ROAD SAFETY AUDIT BRIEF

Project	Land North Of Cambridge, Milton Avenue Cambridge
Report Title	Road Safety Audit Stage 1 – Highway Improvements

Project name	Cambridge North Development (Cowley Circus)
Audit Number & Stage	SA2277 - Stage 1
Date:	30.11.22
Prepared by:	Greg Dobbins (PJA Civil Engineering Ltd)
On behalf of:	Brookgate Property Ltd

Project Name: Cambridge North Development (Cowley Circus)

PJA JOB No.	SUB-CODE	DRAWING NO.	REVISION
05425	- C -	2113	- P3

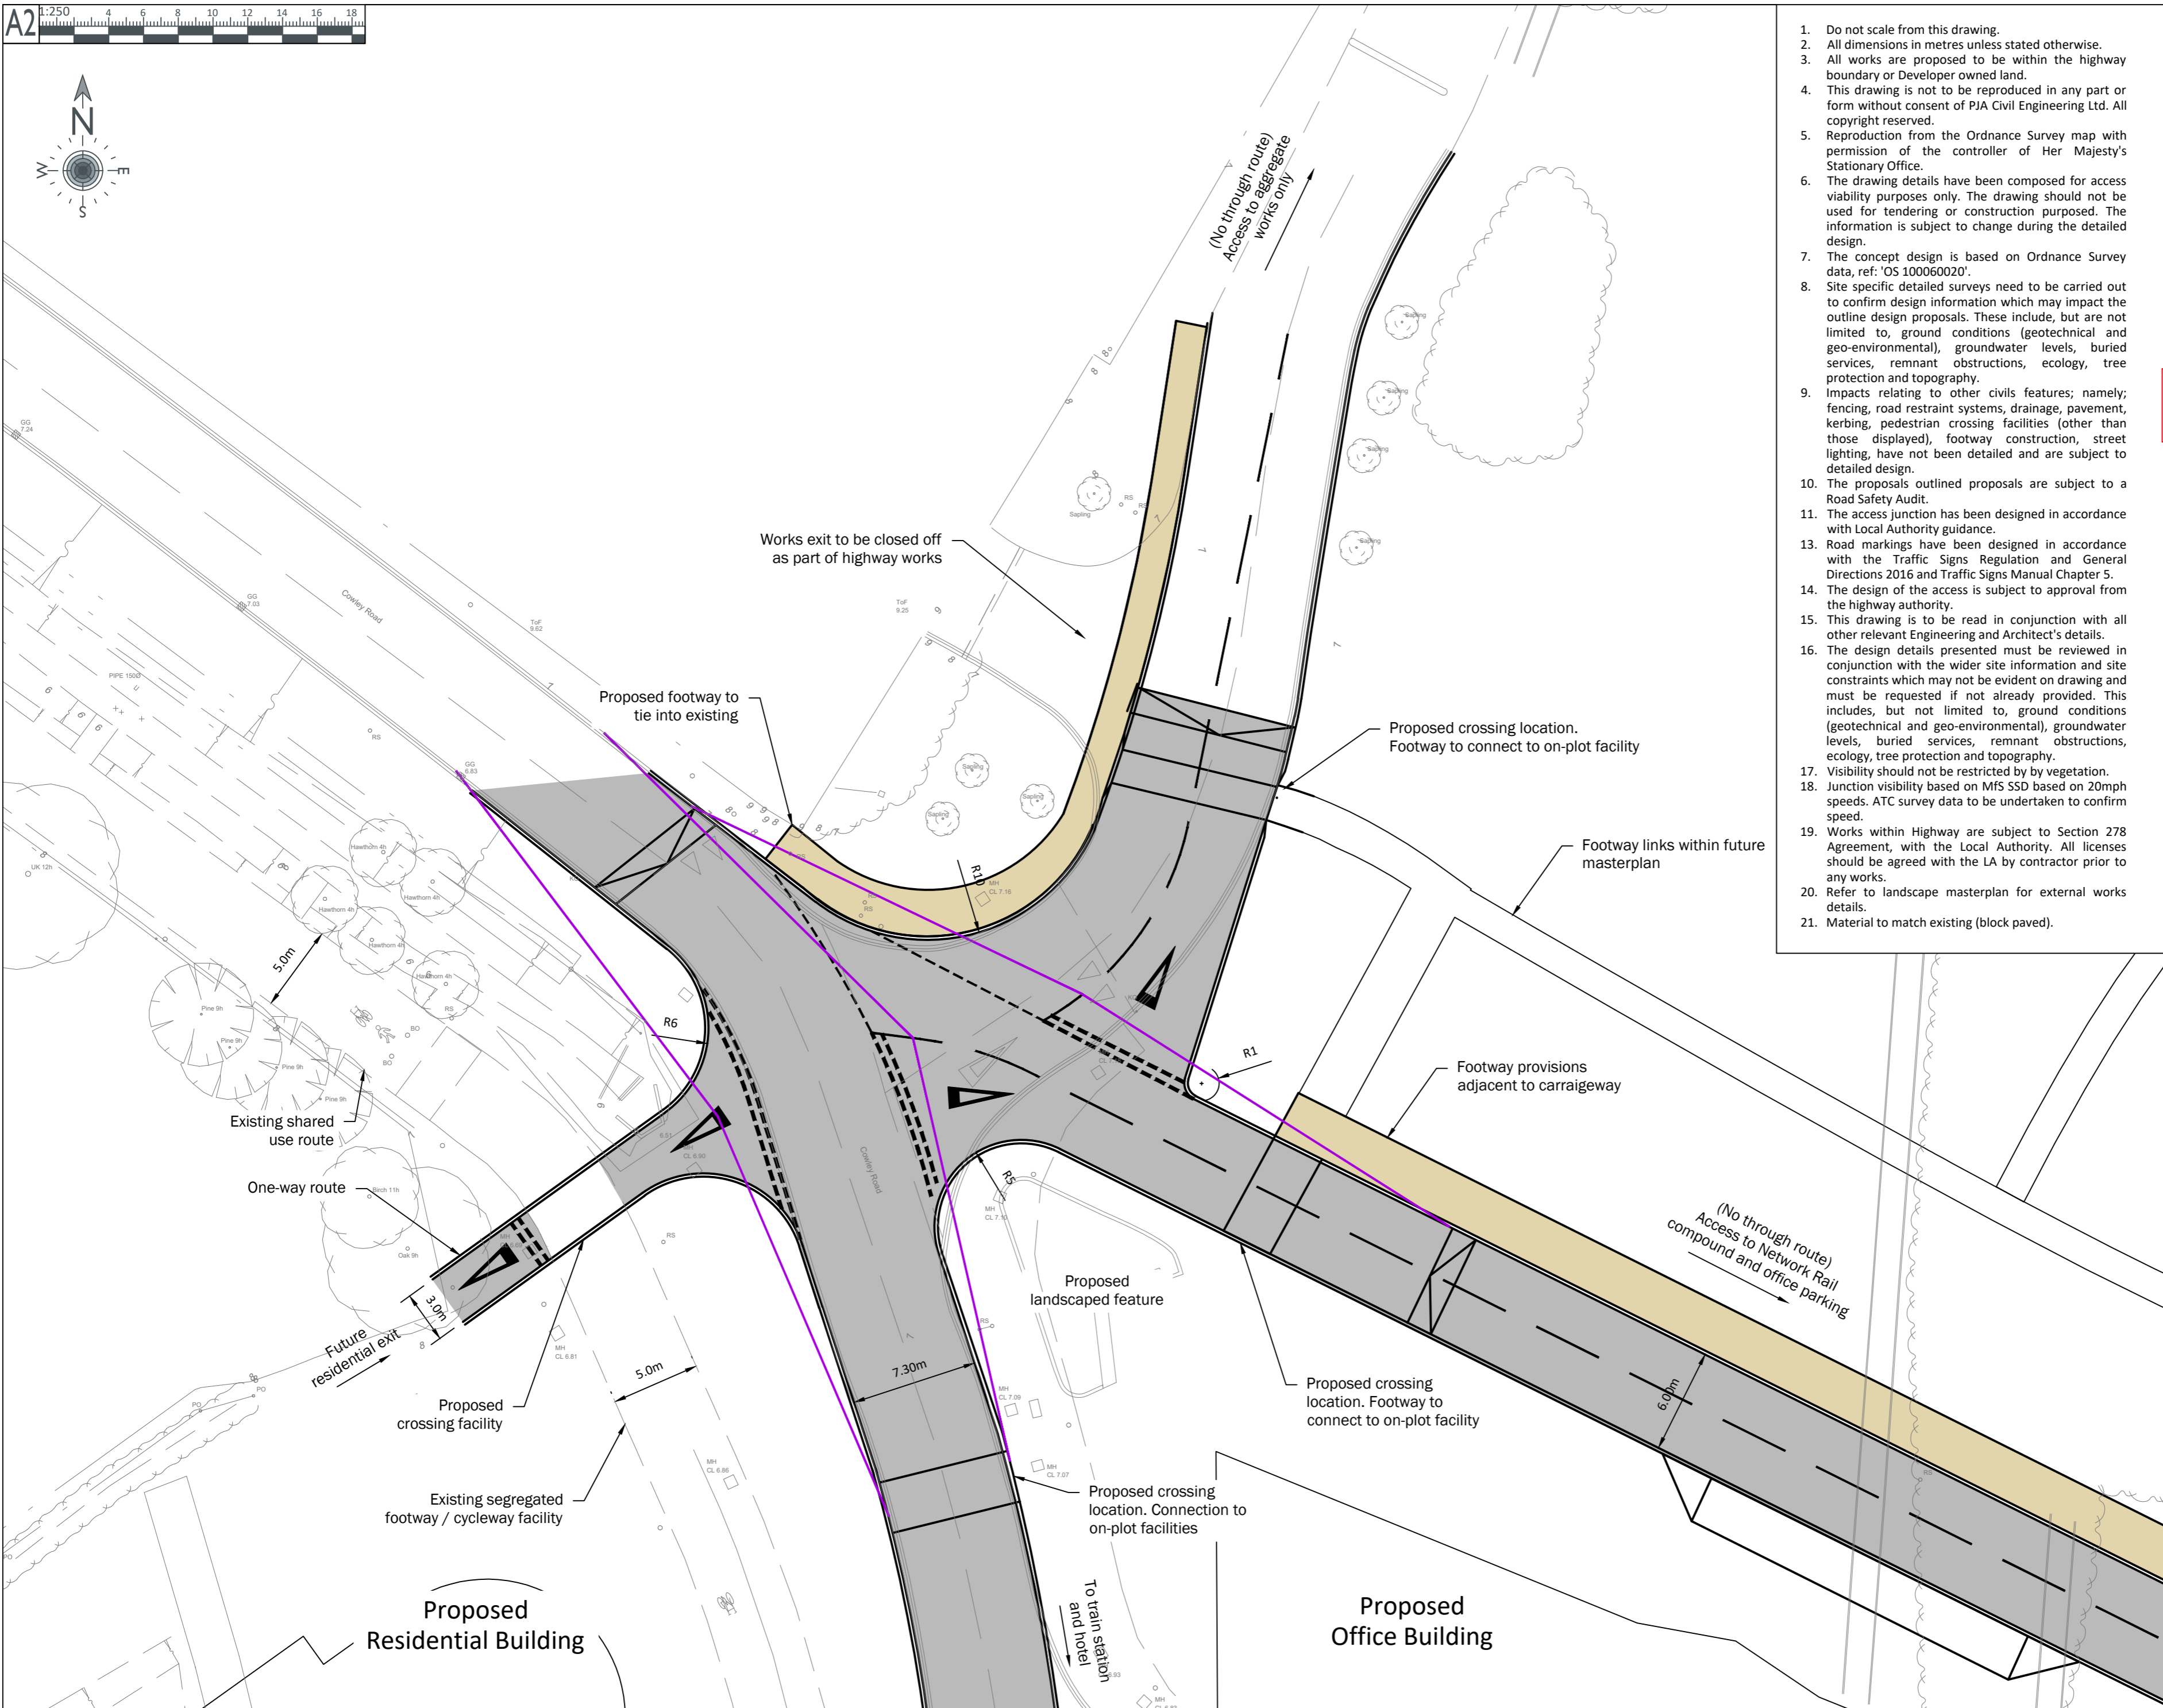
1. No details of planning application provided with this Audit request e.g. numbers of residential units, commercial units, etc. This will clearly have a bearing on movement levels and details provided for these are particularly sketchy.
2. Vehicle tracking details have not been provided for the proposed layout. A vehicle exiting the aggregates access road onto the Network Rail compound access road may block the path of an oncoming vehicle turning left from Cowley Road.
3. The drawings provided detail an existing footway to the northern side of Cowley Road which was observed on site not to be there. Tie-in details for the proposed footway termination at this point should be reconsidered.

PJA JOB No. SUB-CODE DRAWING NO. REVISION
05425 - C - 2113 - P4

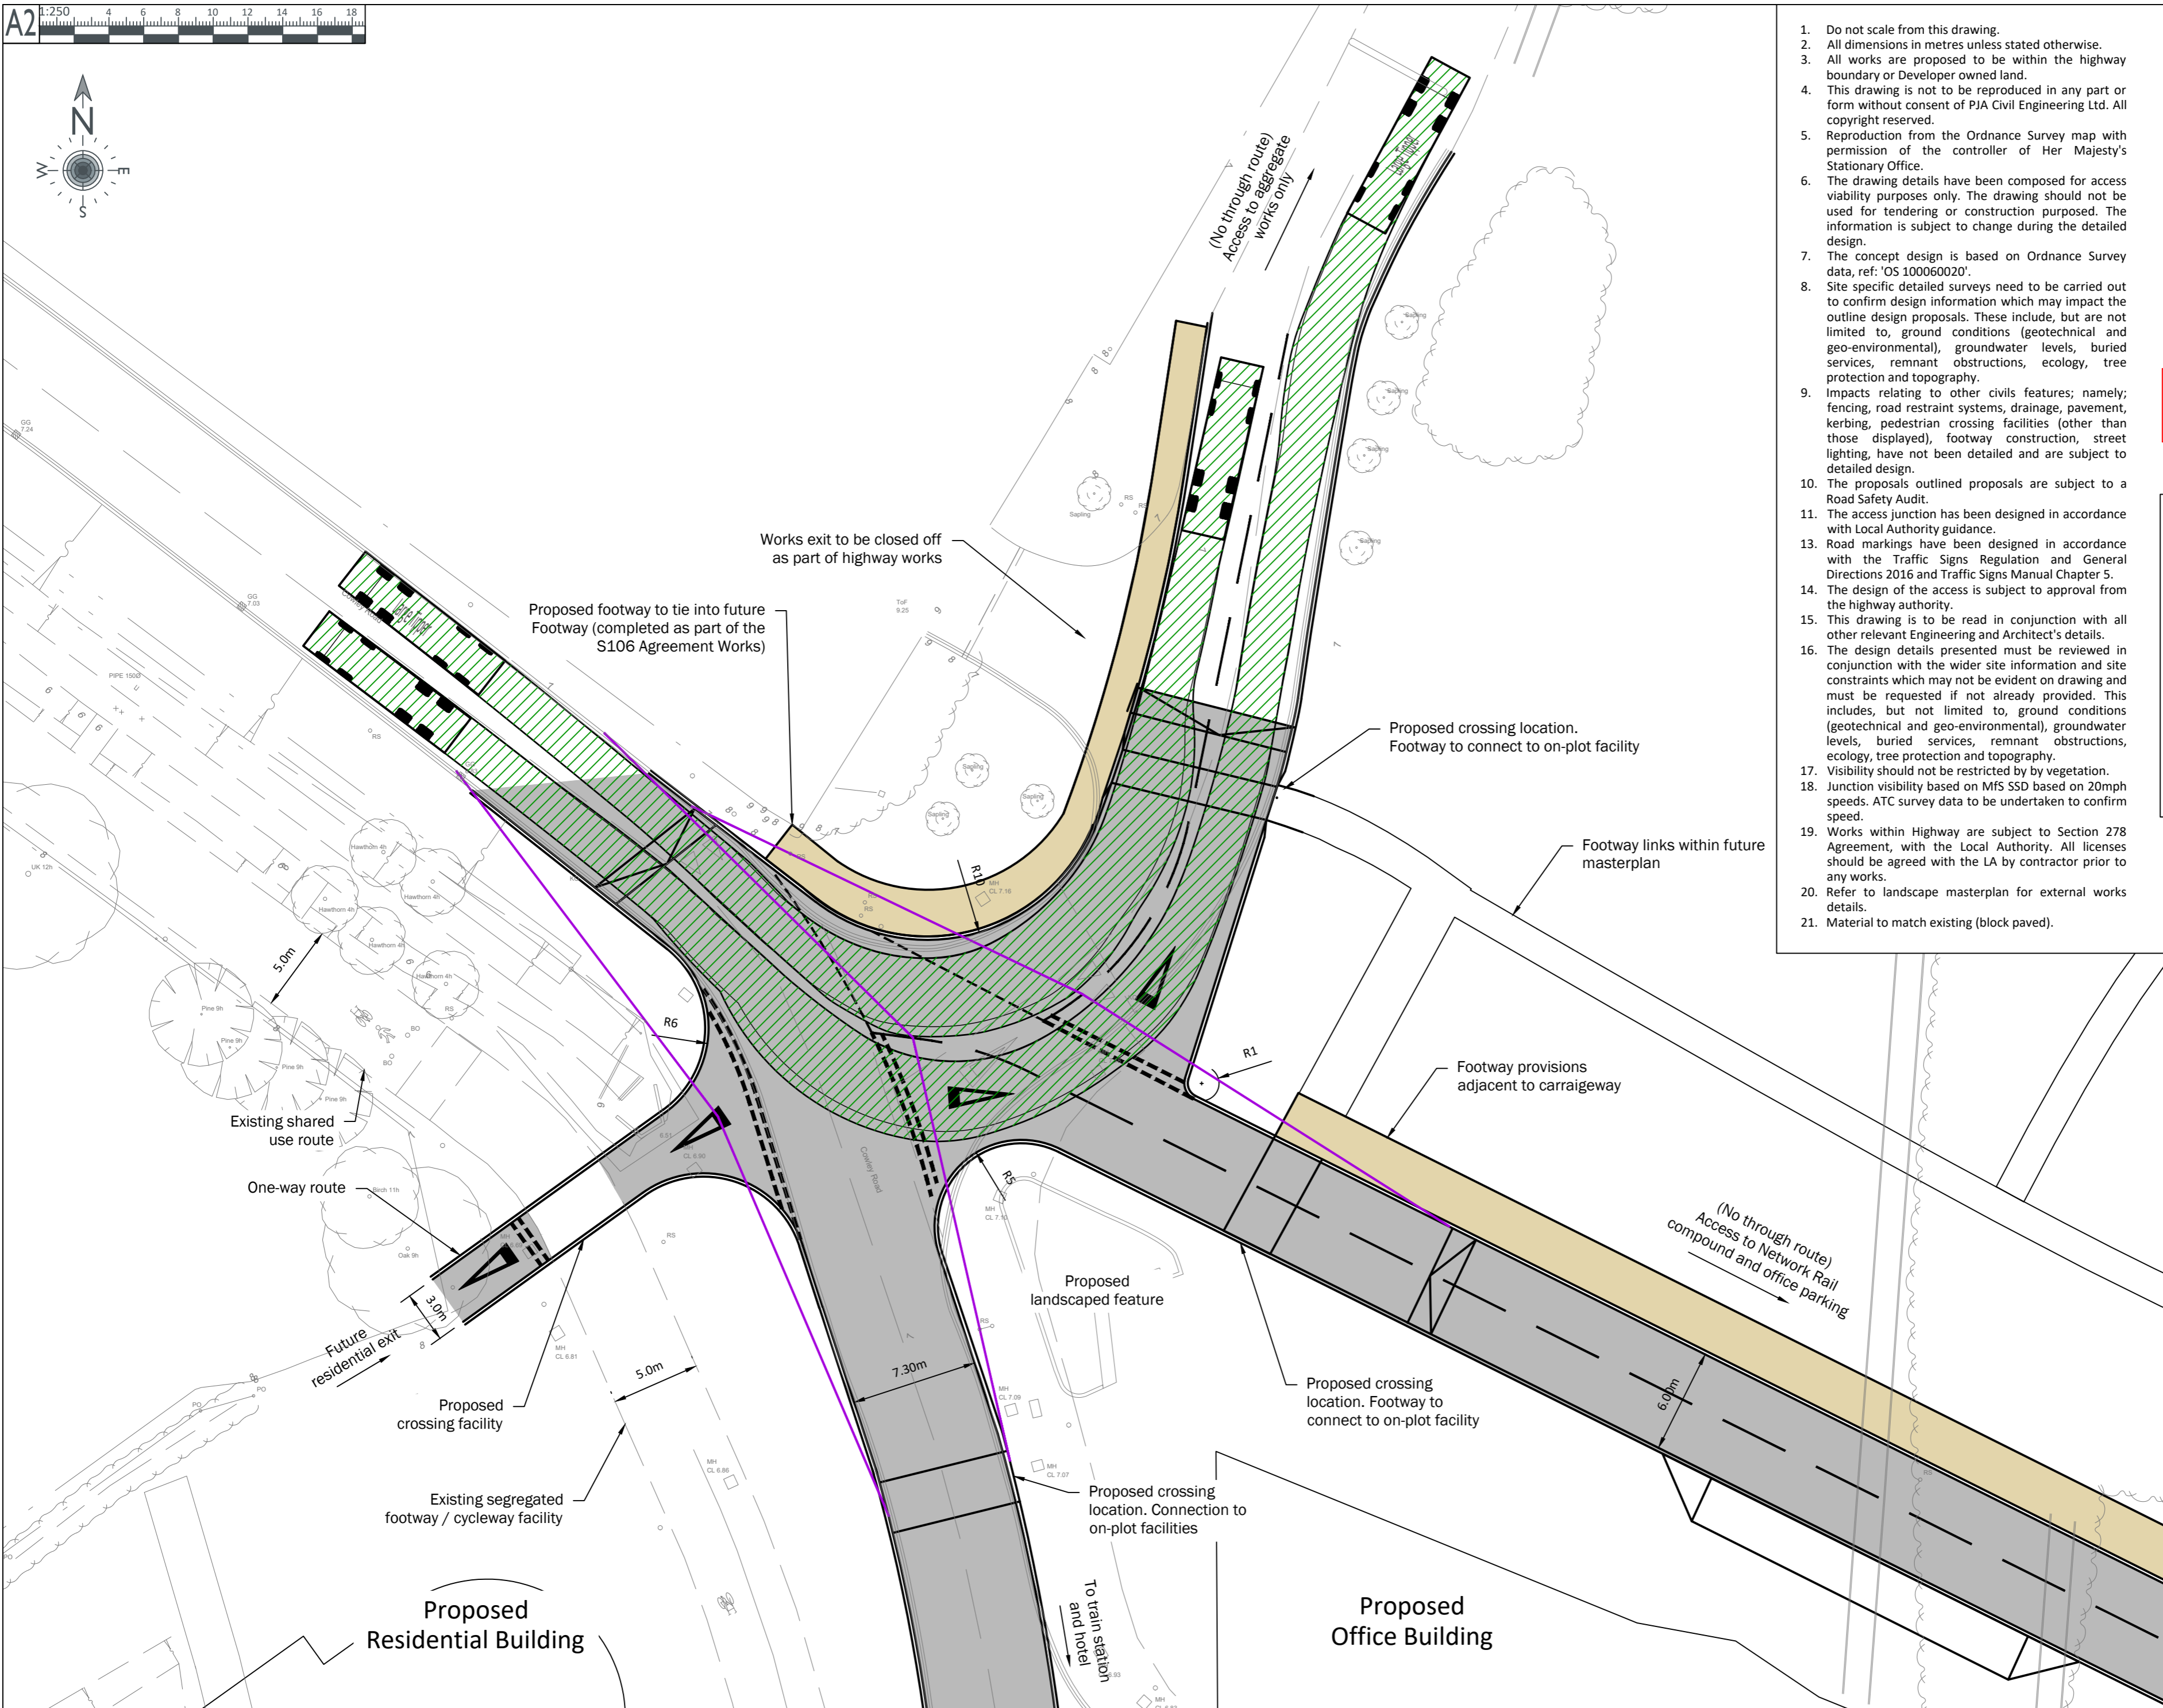
2.2 - Tight junction radii could lead to vehicle overrunning of the footway or head on collisions	It is recommended that vehicle tracking should be undertaken to ensure that all expected vehicle types can safely manoeuvre the junction without any overrunning	Vehicle Tracking demonstrating large tipper trucks using the junction leading up to the aggregate works has been added back onto the drawing <i>05425-C-2113-P4 Cowley Circus</i> , having been removed for clarity. This shows that in the main, the size of the junction has been increased and that the manoeuvres can be undertaken without overrunning. PJA drawing <i>5425-C-2208 Refuse Vehicle Tracking</i> has been included which shows the

<p><u>Additional Comments</u> The drawings provided detail an existing footway to the northern side of Cowley Road which was observed on site not to be there. Tie-in details for the proposed footway termination at this point should be reconsidered</p>		<p>The comment has been amended on drawing <i>05425-C-2113-P4 Cowley Circus</i>.</p> <p>It is intended that a footway be provided on this section of Cowley Road as part of S106 works, at which point the footway will tie in.</p>		
---	--	---	--	--

council approved refuse vehicle using the junction. Tracking shows that the refuse vehicle can make the manoeuvre without overrun, whilst using all the carriageway. This was deemed acceptable due to the limited number of trips that the vehicle would make (1 per week).

SA 2277 – Cambridge North Development (Cowley Circus)
Stage 1 RSA
Problem Location Plan (NTS)

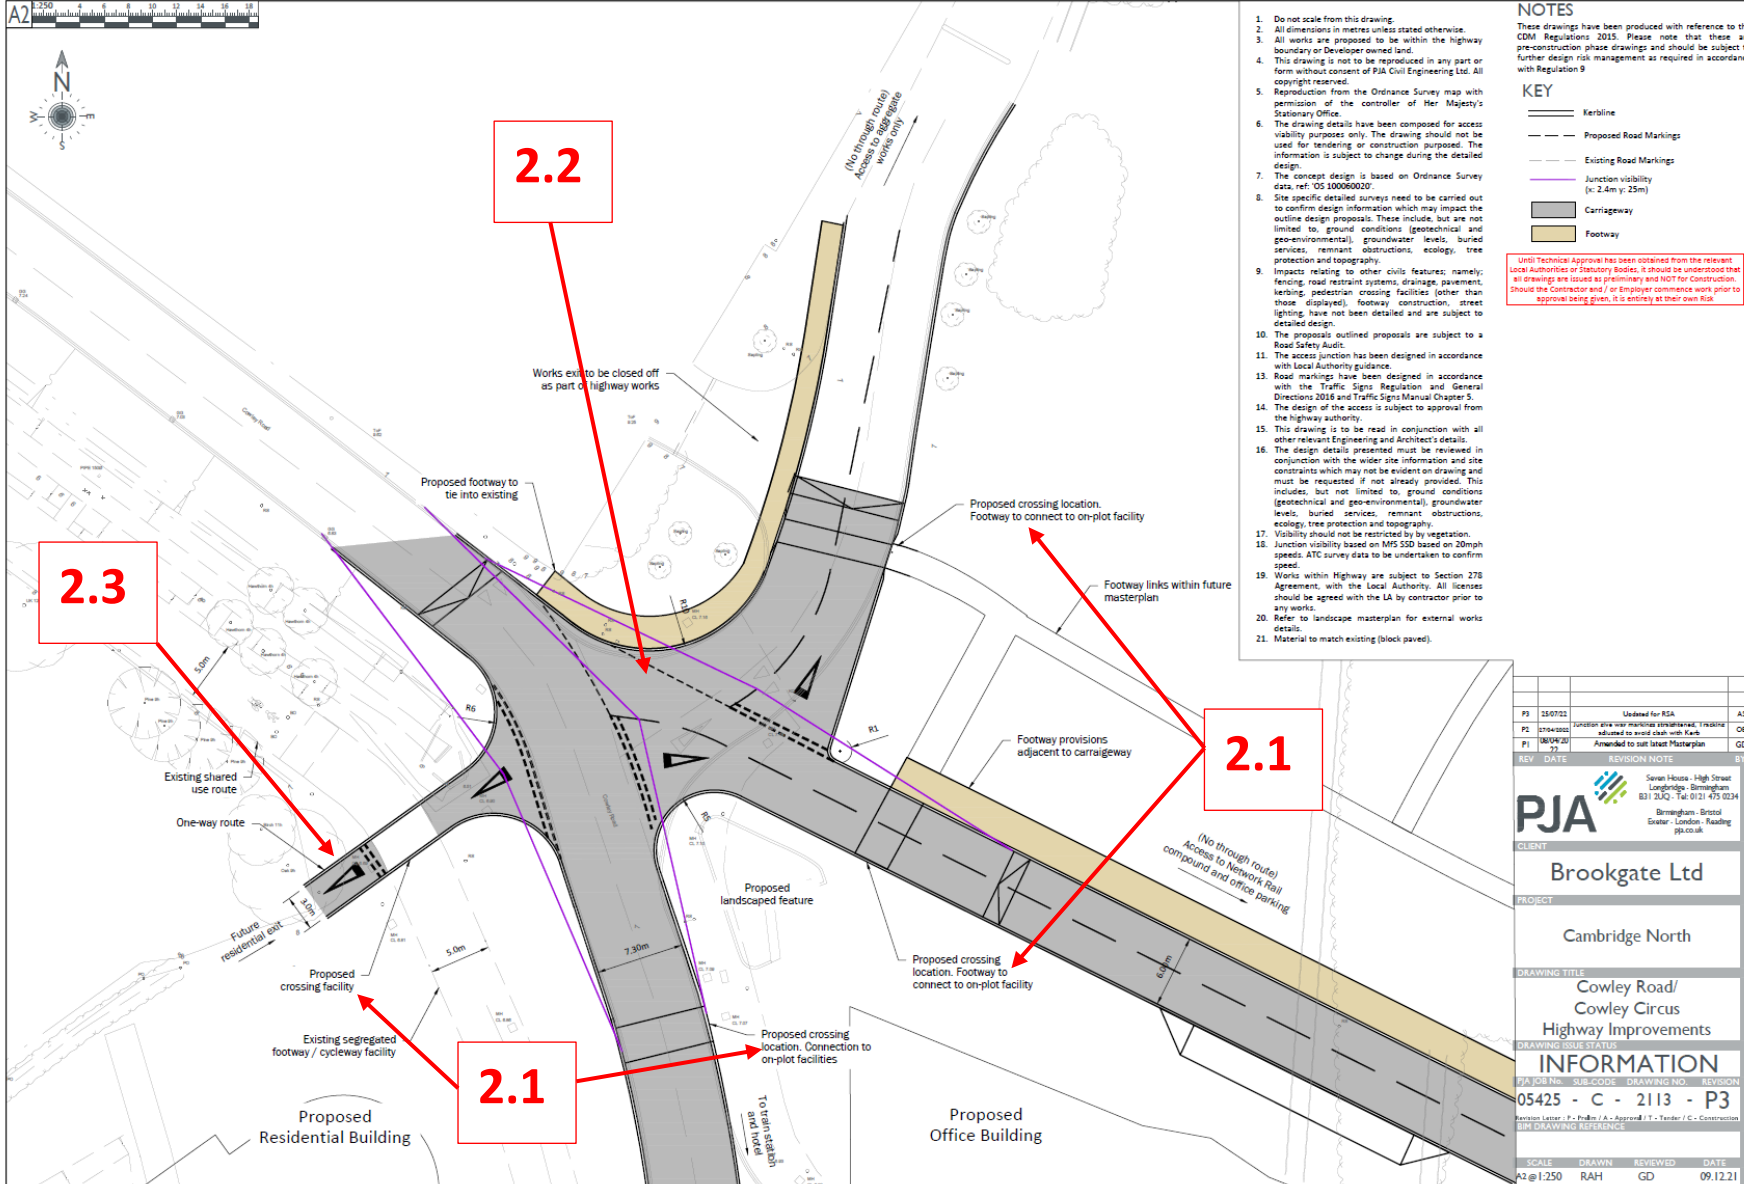
Summary: Absence of tactile paving could lead to vehicle/pedestrian collisions or pedestrian trips and falls

The drawings provided detail several proposed crossing locations whereby the type of crossing to be provided has not been shown. No dropped kerbs or tactile paving have been shown associated with the proposed crossings which could leave blind or partially sighted pedestrians vulnerable of being unable to find a safe place to cross resulting in collisions with vehicles. Furthermore, the absence of dropped kerbs could lead to pedestrian trips and falls as a result of crossing where there is a full height kerb.

Summary: Tight junction radii could lead to vehicle overrunning of the footway or head on collisions

No vehicle tracking has been provided to the Audit Team for assessment. It is Unclear to the Audit Team whether larger vehicles, such as the tarmac trucks which were observed during the site visit, are able to turn left from Cowley Road into both the Network Rail compound access and the aggregates access road without overrunning the footway or opposing carriageway lanes. This could lead to head on collisions or collisions with pedestrians using the footway.

Summary: Fence within visibility splay could lead to vehicle collisions with pedestrians or cyclists

The drawings provided show a proposed future residential exit road onto Cowley Road. During the site visit a fence was observed to the north of the proposed road which, if left *in situ* could restrict drivers' visibility of pedestrians and cyclists using the shared route facility crossing over the access road at this location. This could lead to vehicle collisions with pedestrians or cyclists.

It is recommended that the types of crossings proposed should be provided and associated dropped kerbs and tactile paving should be included within the design to suit.

It is recommended that vehicle tracking should be undertaken to ensure that all expected vehicle types can safely manoeuvre the junction without any overrunning.

It is recommended that visibility splays should be checked and kept free from obstructions.
